REVIEW PENDING

PROJECT NAME:	SQ ALEXANDRA PARK - BLOCK 11
DRAWING TITLE:	9th FLOOR ELEVATIONS
ARCHITECT:	TEEPLE ARCHITECTS
CONTRACTOR:	TRIDEL
SCALE:	1:50
DRAWN BY:	S.C.
DATE:	MARCH 4, 2015

DRAWING No.:  
**E9-18**

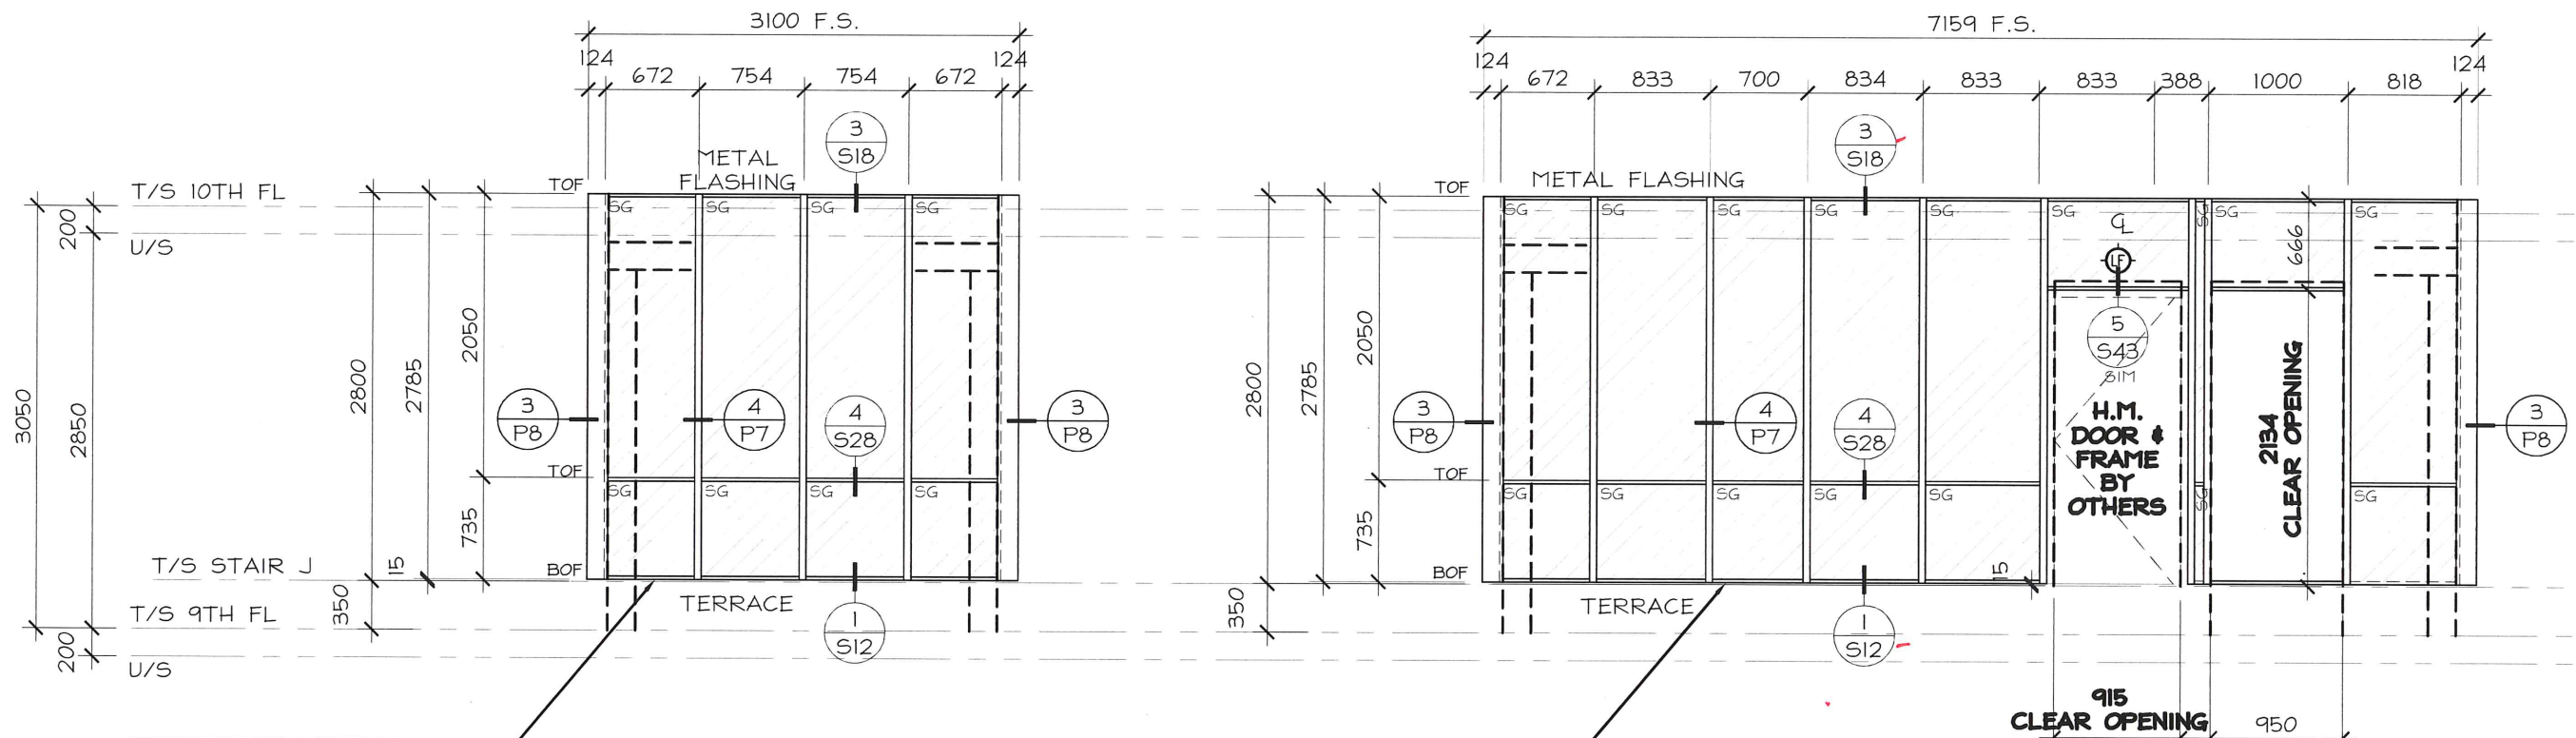
ARCHITECT: PROVIDE CONCRETE CURB FOR WINDOW SUPPORT. REFER TO ARCHITECTURE DETAILS 7/A609

ARCHITECT: PROVIDE CONCRETE CURB FOR WINDOW SUPPORT. REFER TO ARCHITECTURE DETAILS 7/A609
